CHILDREN'S HOSPITAL AND RESEARCH CENTER OAKLAND CAMPUS MASTER PLAN PROJECT RESPONSE TO COMMENTS DOCUMENT

STATE CLEARINGHOUSE NO. 2013072058

February 2015

FIGURE IV.D-25 - Revised

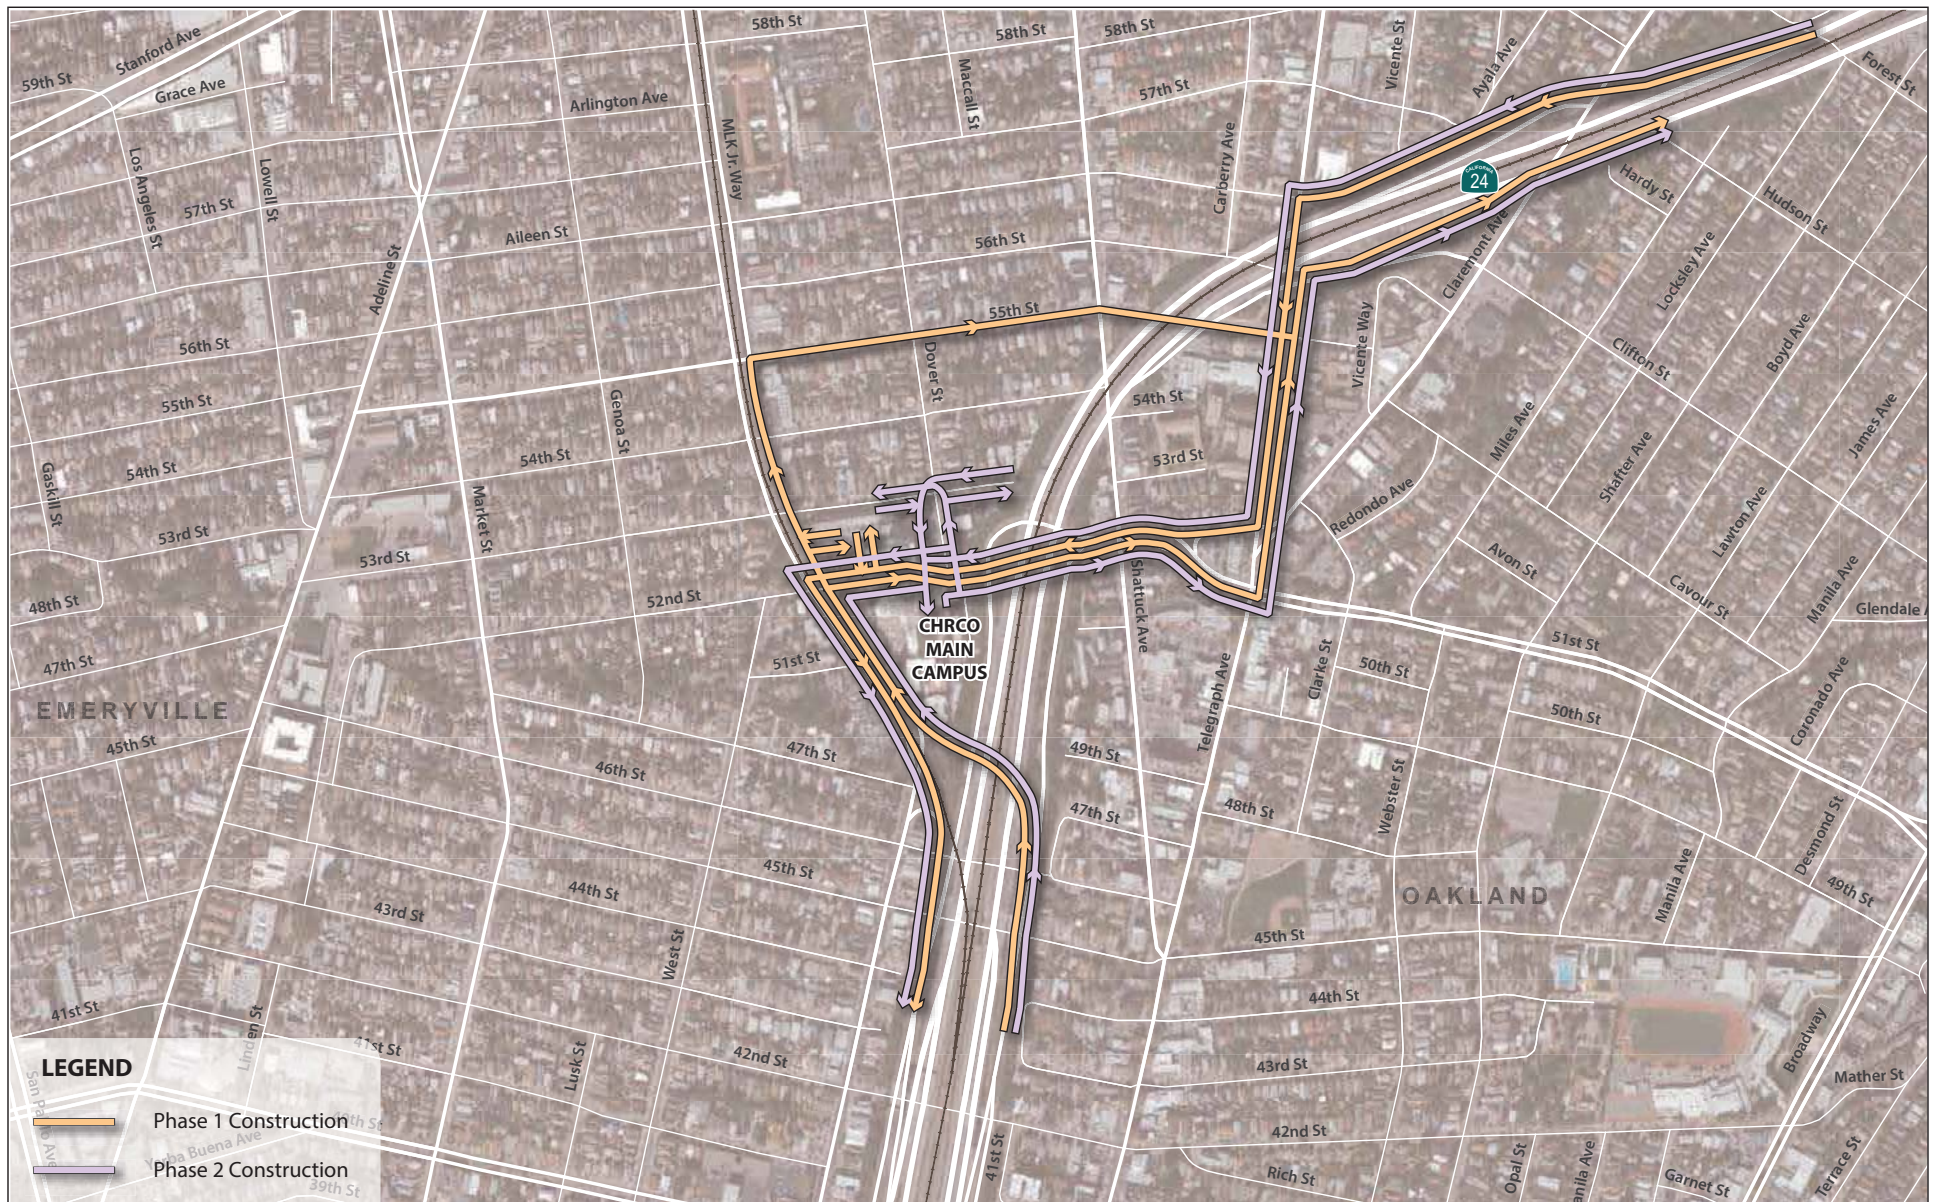
- Construction truck routes – As noted above, the Draft EIR evaluates construction truck routes, and concludes that those impacts would be less than significant (see page 350 of the Draft EIR). In addition, SCA TRA-2, item o, identifies construction truck traffic routes on the streets shown on Figure IV.D-25 to ensure that construction staging would result in a less than significant impact. Figure IV.D-25 has been revised and updated for the Final EIR (see Revised Figure IV.D-25 in Chapter IV of this RTC Document). To the extent feasible, trucks are limited to non-residential streets, such as Martin Luther King Jr. Way, Telegraph Avenue, 55th Street, and 52nd Street. Since Phase 1 would include the demolition of minor rear yard additions to accommodate the new maintenance access route and Phase 2 of the

project would include buildings on Dover and 53rd Streets (construction of the Family House and relocation of the two houses from 52nd Street to 53rd Street), trucks would need to use these streets because no other access is available. However, trucks would only use the segments of Dover Street between 52nd and 53rd Streets and 53rd Street just east and west of Dover Street. Trucks on these street segments would be limited to those trucks serving the construction site, and no other trucks would use these street segments for through travel as shown on the Revised Figure IV.D-25.

Figure IV.D-25 on page 351 of the Draft EIR is revised as shown on the following page.

FIGURE RTC-V-1

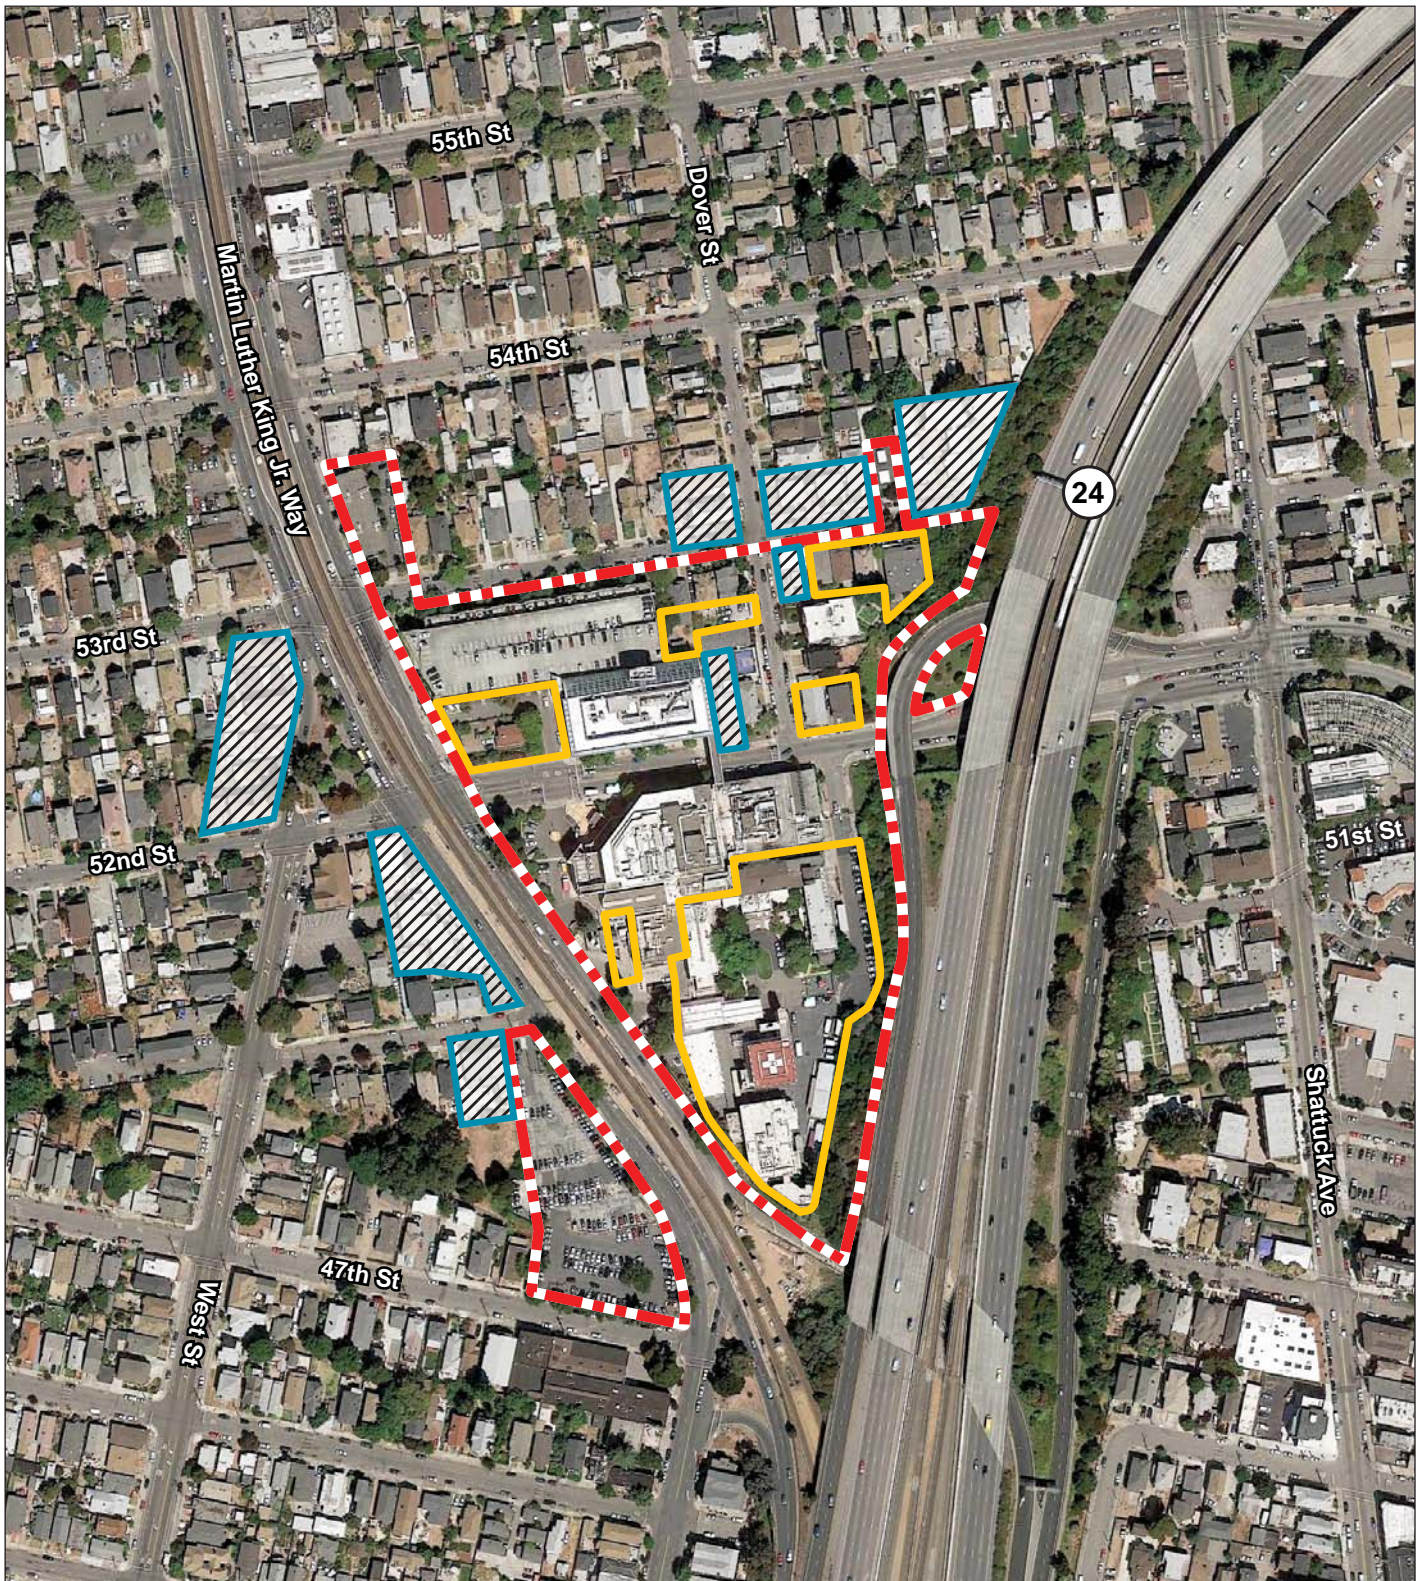
Several commenters expressed concern regarding the days and hours of construction, measures to reduce noise near residents, notification of extreme noise events, noise complaint procedures, and the definition of heavy as opposed to light construction. As shown in Draft EIR Figures III-8a through 8d, construction of the project would occur at different locations throughout the 11-acre property and many months of construction would be interior renovation work, which would not result in any significant noise impact to the surrounding areas. Figure RTC-V-1 further shows the location of specific construction areas on the project site and the proximity of noise-sensitive receptors that were identified in the Draft EIR analysis, including residential areas located across Martin Luther King Jr. Way.

Construction noise impacts are evaluated on pages 461 to 465 of the Draft EIR. Construction-related noise levels would be reduced with implementation of Standard Conditions of Approval (SCA) NOI-1, SCA NOI-2, SCA NOI-3, and SCA NOI-6 (see pages 441 to 443). Elements of construction-related noise SCAs are described in greater detail below:

- Hours of construction – Consistent with the City of Oakland Noise Ordinance, SCA NOI-1 limits the hours of construction to between 7:00 a.m. and 7:00 p.m. on Mondays through Saturdays. However, Saturday construction is typically limited to only after the building is enclosed and doors and windows are closed. Furthermore, construction on Saturdays and outside of standard hours will be evaluated by the building department on a case-by-case basis with consideration given to the proximity of residences and resident's preference if construction will be shortened. The Bureau of Building will provide written authorization if approval of days and hours beyond regular limits is granted. Extreme noise-generating activities are limited to 8:00 a.m. to 4:00 p.m. Monday through Friday. No extreme noise are permitted on Saturday with no exception. No construction can occur on Sunday or Federal holidays.

FIGURE RTC-V-2a

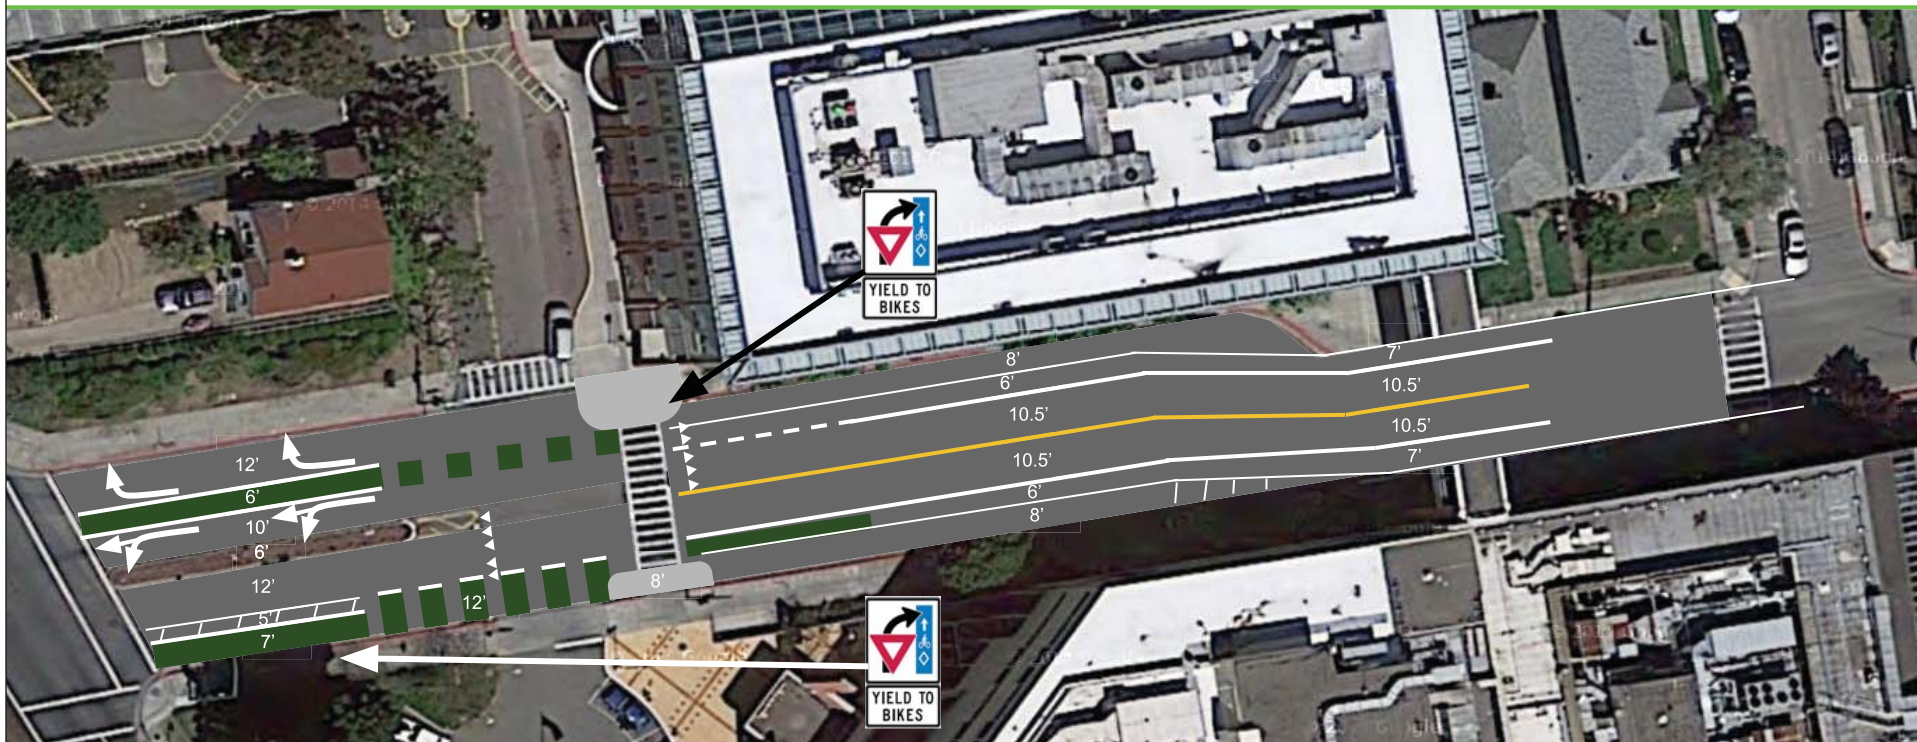
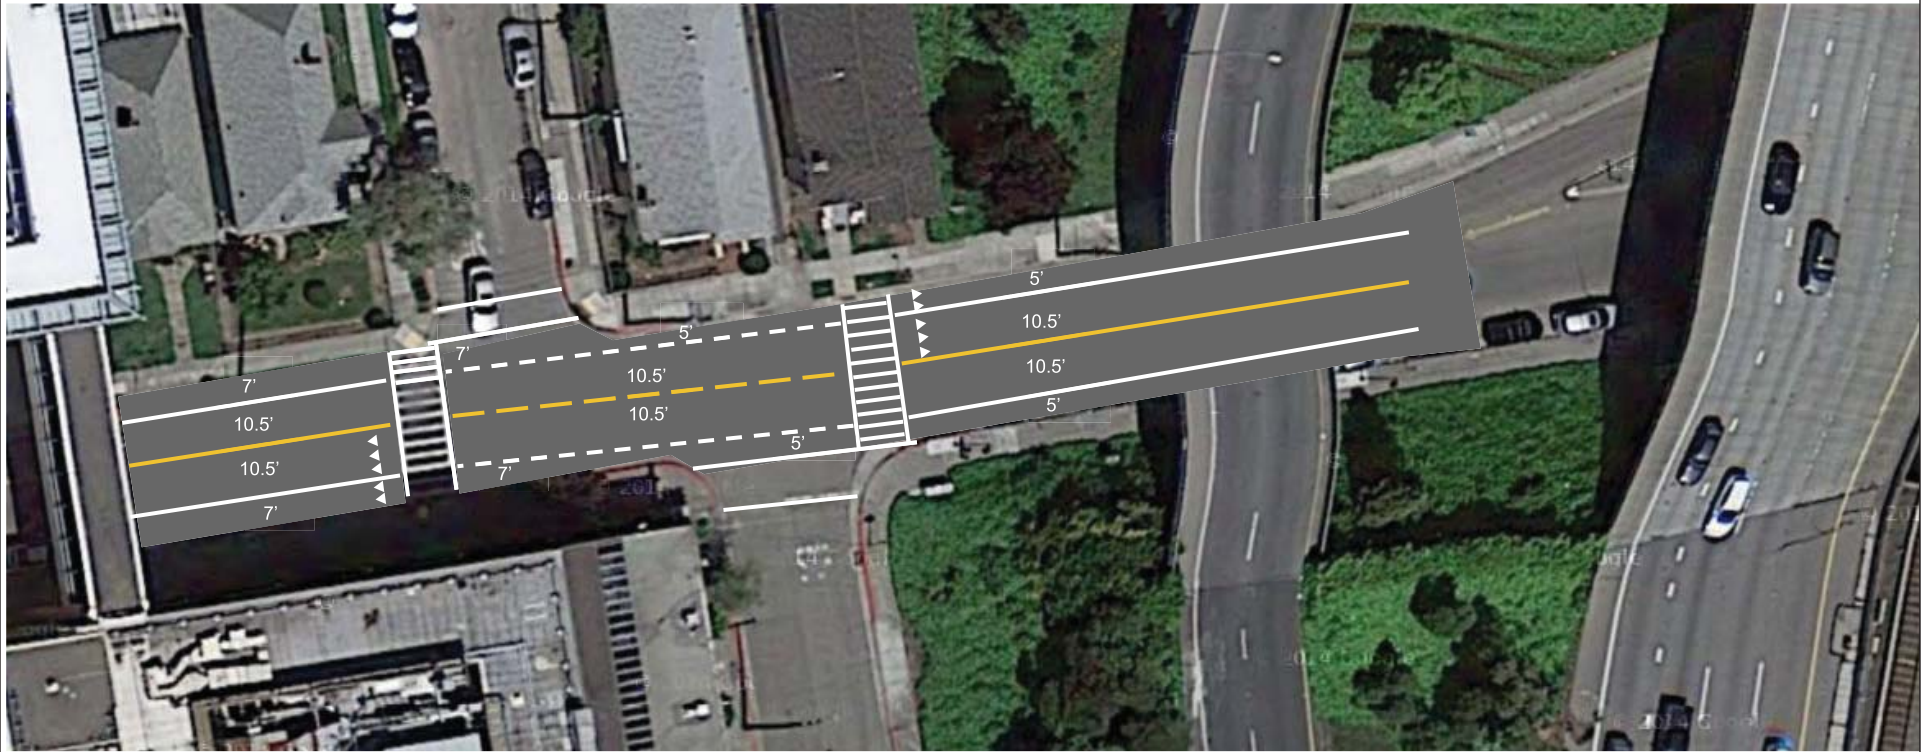
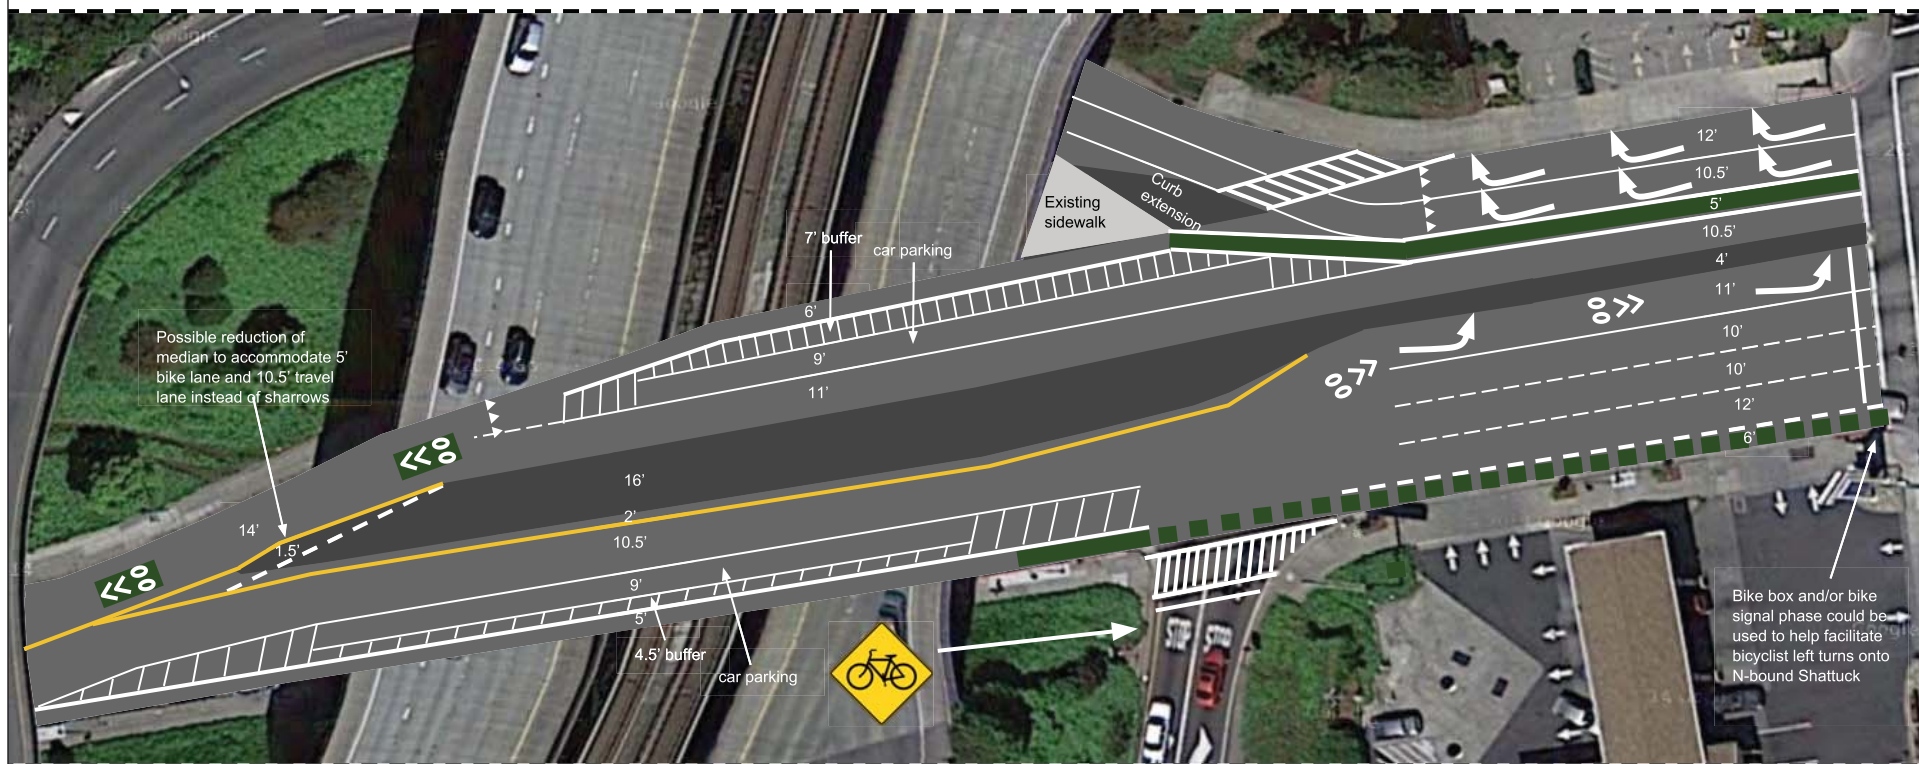
- Safety at SR 24 Ramps –The Draft EIR includes the following recommendations to improve safety for pedestrians and cyclists on 52nd Street at the SR 24 Ramps (see Recommendation TRA-4 and the improvements illustrated in Figure IV.D-24 on page 345):
 - Prohibition of on-street parking on the south side of 52nd Street adjacent to the SR 24 Eastbound Off-Ramp to provide sight-distance for motorists on the off-ramp, which is consistent with the Alternative Design.

- Advanced yield markings – Recommendation TRA-4 as shown on Figure IV.D-24 does not include any advanced yield markings (shark teeth markings). The Alternative Design proposes advanced yield markings on the crosswalk across the SR 24 on-ramp and on both directions of 52nd Street at the pedestrian crossing at the existing Main Garage Driveway. As previously noted, the markings at the SR 24 on-ramp will be considered for inclusion in Recommendation TRA-4. However, the markings on 52nd Street at the pedestrian crossing at the existing Main Garage Driveway cannot be implemented because the intersection, including the pedestrian crossing, is signal controlled and advanced yield markings are not installed at signalized locations because they would conflict with the signal.

The final design for the 52nd Street bikeway will be prepared as part of Phase 2 of the proposed project based on engineering standards, best practices, and the City's guidelines and policies in effect at that time. Therefore, the following bullet is added to the list under Recommendation TRA-4 on Page 344 of the Draft EIR:
